Changes are as below.

Samsung Electronics Co., Ltd. FCC ID : A3LNQ9300

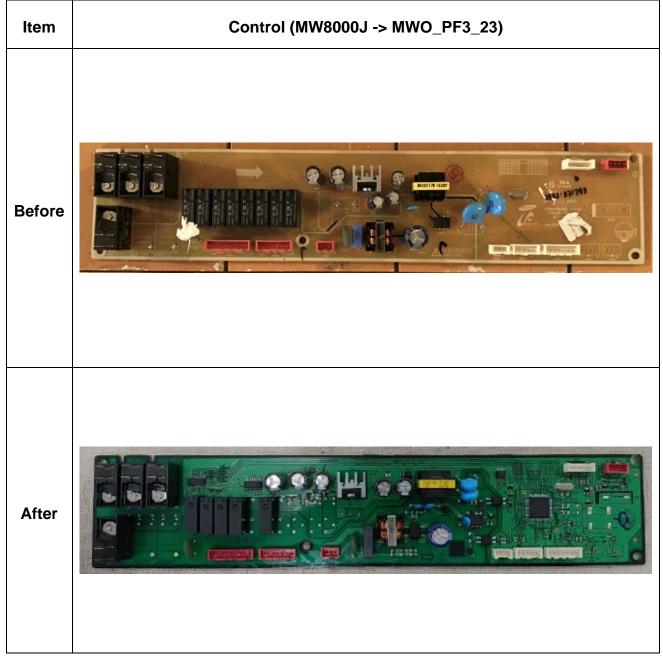
- 1. There is change of control board
 - 1) Add wireless module by FCC certified
 - 2) New control board (Non-transmitter portion)
 - Overcurrent protection design (Fuse+add NCT)
 - Temperature protection design (add OTP circuit)
